Project	IEEE 802.16 Broadband Wireless Access Working Group <http://ieee802.org/16>	
Title	Integration of comments #5482, #5484, #5487, their reply comments, contribution 289, 305 and 118r4 on fast DL S/N measurements	
Date Submitted	2005-06-16	
Source(s)	Masoud Olfat Nextel Communications 12000 Sunrise valley Dr. Reston VA 20191	Masoud Olfat Nextel Communications 12000 Sunrise valley Dr. Reston VA 20191
Re:	IEEE P802.16e/D8	
Abstract	This contribution integrates comments #5482, #5484, #5487, their reply comments, contribution 289, 305 and 118r4 on fast DL S/N measurements, and changes some portions based on the D8 draft.	
Purpose	Discuss and approve.	
Notice	This document has been prepared to assist IEEE 802.16. It is offered as a basis for discussion and is not binding on the contributing individual(s) or organization(s). The material in this document is subject to change in form and content after further study. The contributor(s) reserve(s) the right to add, amend or withdraw material contained herein.

Integration of Comments 5482, 5484, 5487 and all their reply comments, contributions 289, 118r4, 305

Masoud Olfat
Nextel Communications

Figure 230a – Post Processing S/N for MIMO Region

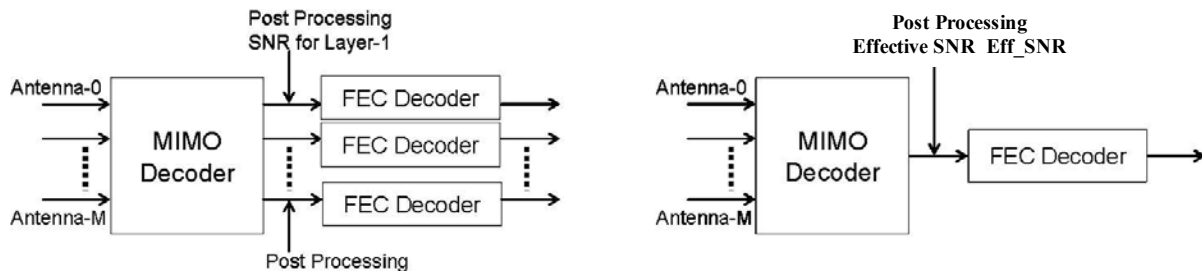
[Replace the first half of the figure 230a with the one from contribution 305]
